ADDENDUM NO. 2  
 NEW LIBERTY PARK MIDDLE SCHOOL - PHASE II  
 Architect's Job No. 06-48  
 May 22, 2007

The Plans and Specifications are here by amended. The following supersedes all contrary and/or conflicting information and is made part of the contract documents.

JOB NO. 06-48
SHEET NO:
AD2.1
1 OF 2

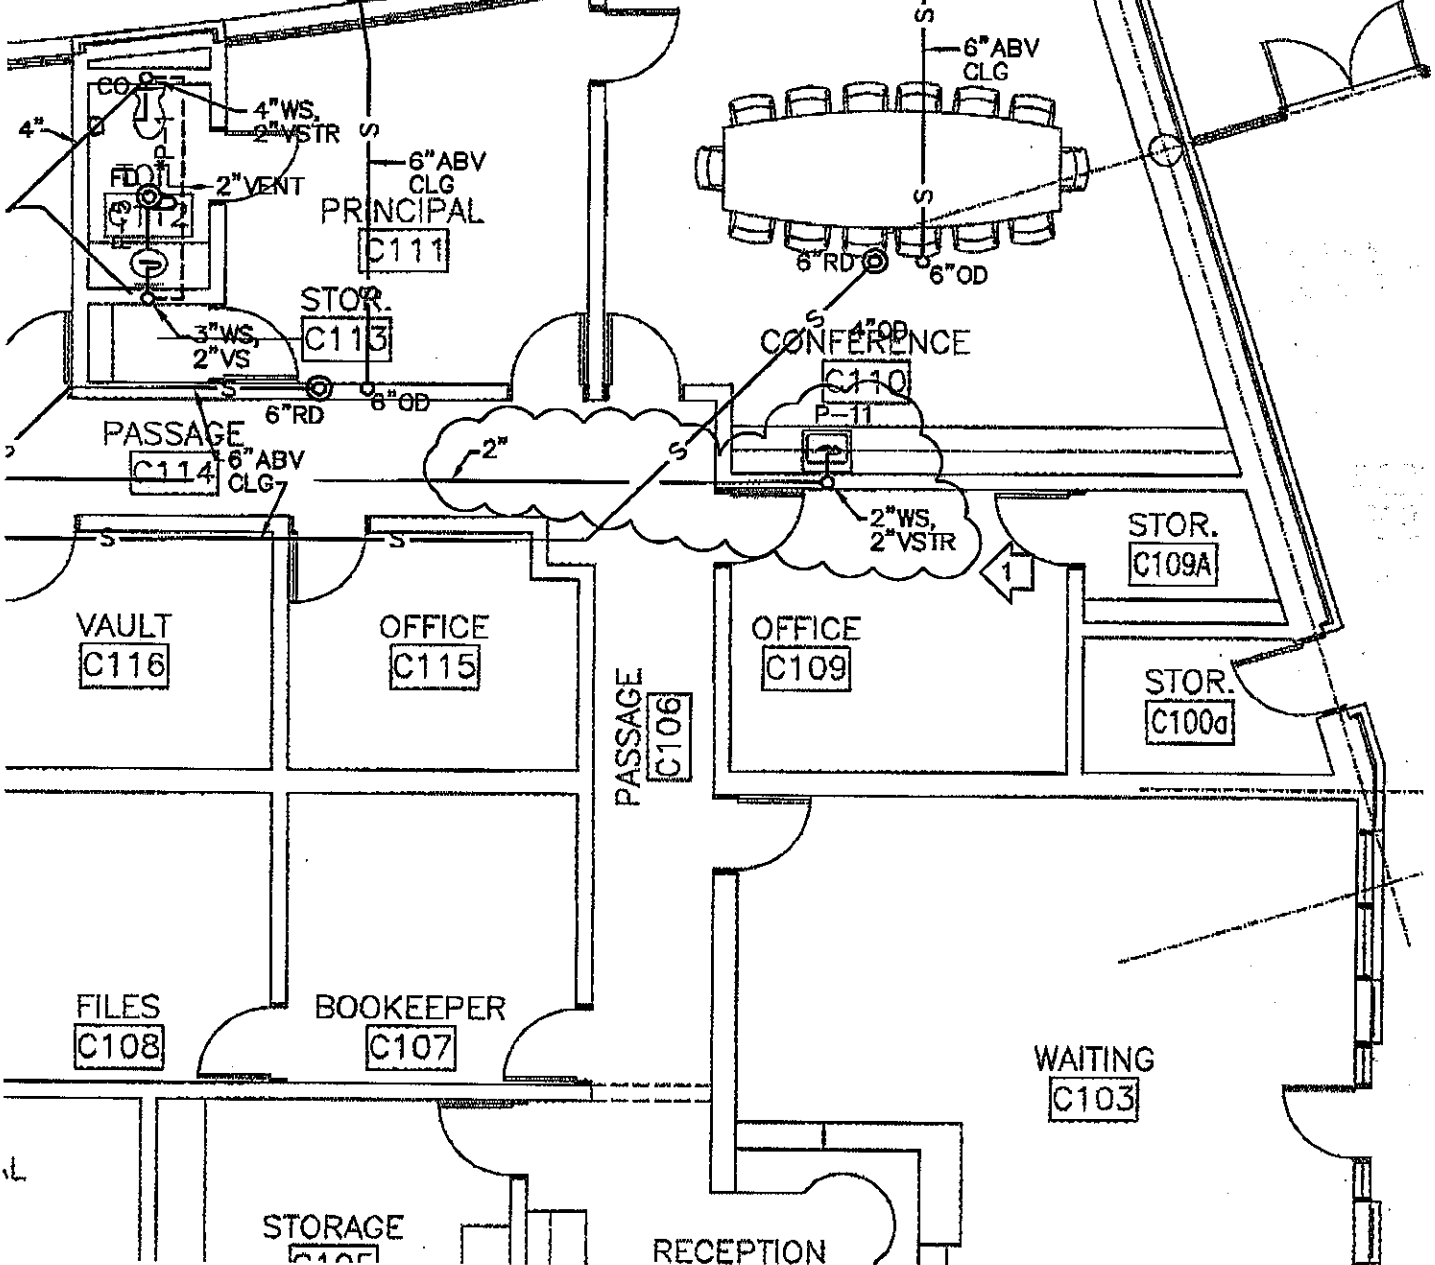
1. See attached Supplemental Drawings **AD2.1 and AD2.2** for detail change on Enlarged Toilet Plan.
2. The 12 type "B" windows indicated on the plans and elevations in **Gymnasium D111** are hereby **deleted**. Provide 12" CMU and face brick in lieu of the windows. Brick color shall be "A". Brick patterns shall remain as shown. The pre-finished metal sun control indicated on **D/A3.1.2** shall also be deleted.
3. **Sheet No. P2.1.1 - First Floor Gravity - Area "C" and Sheet No. P3.1.1 - First Floor Pressure - Area "C"** - See Attached Supplemental Drawings **PSD - 1 and PSD - 2**.
